VAV to SZVAV Field Modification

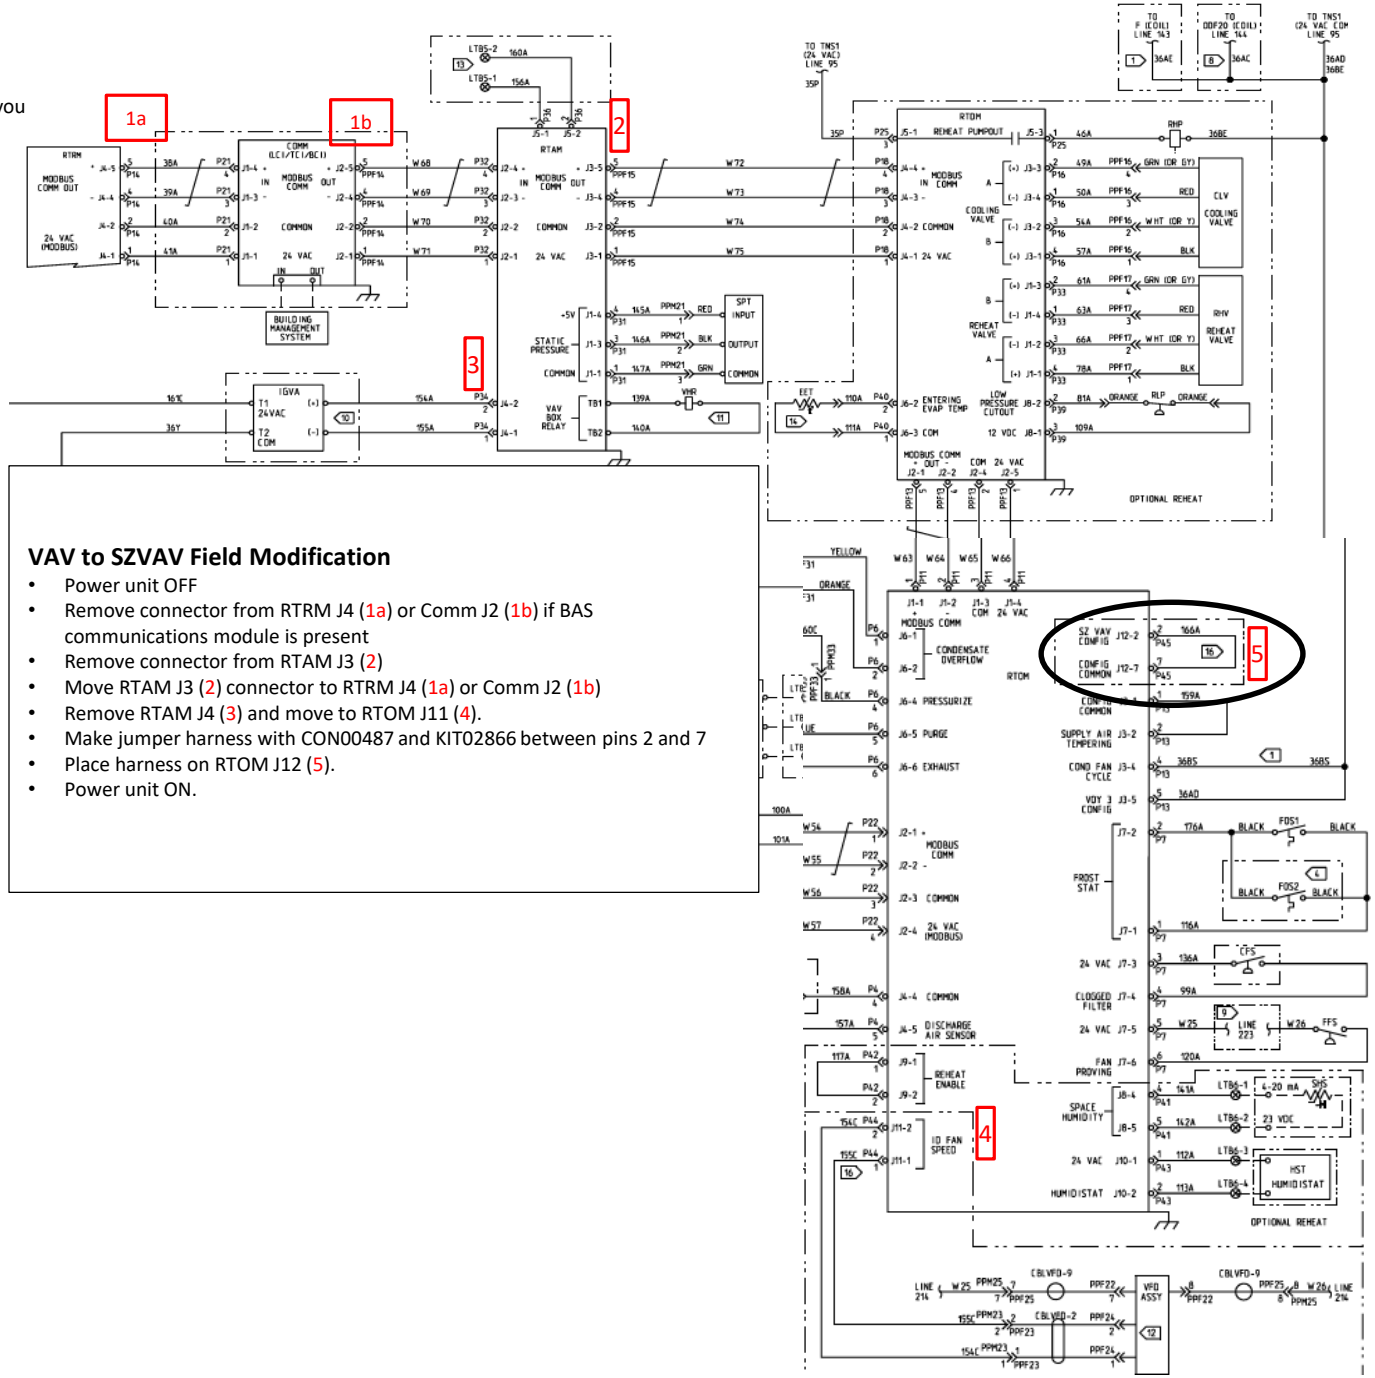
- Power unit OFF
- Remove connector from RTRM J4 (1a) or Comm J2 (1b) if BAS communications module is present
- Remove connector from RTAM J3 (2)
- Move RTAM J3 (2) connector to RTRM J4 (1a) or Comm J2 (1b)
- Remove RTAM J4 (3) and move to RTOM J11 (4).
- Make jumper harness with CON00487 and KIT02866 between pins 2 and 7
- Place harness on RTOM J12 (5).
- Power unit ON.
